Respiratory Belt Oscillator

Title: Respiratory Belt Oscillator J.Beale

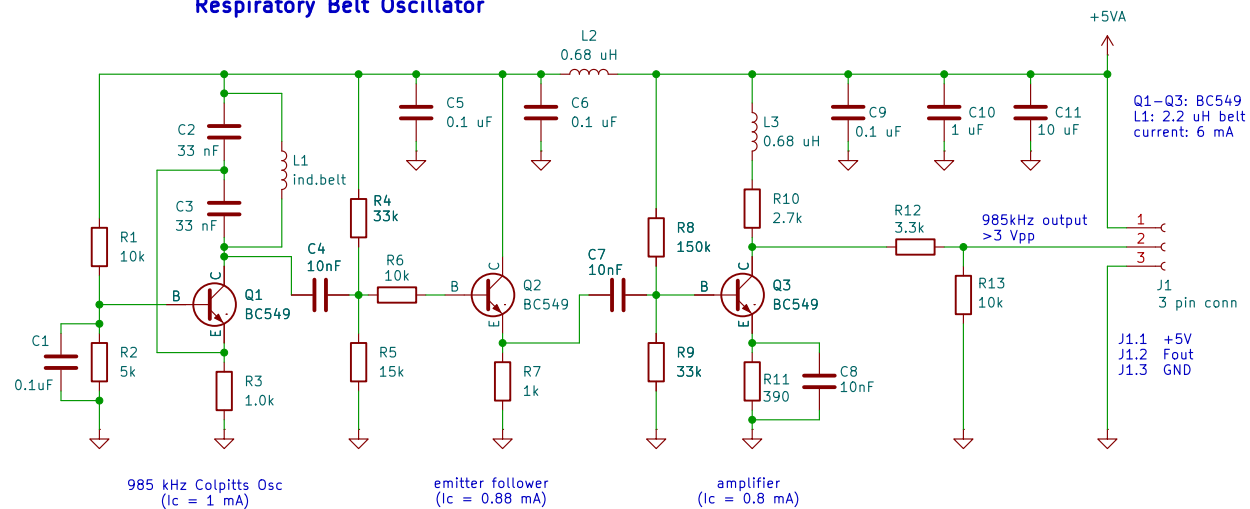
notes: amp Q3 should run a higher collector current. Lower R11.
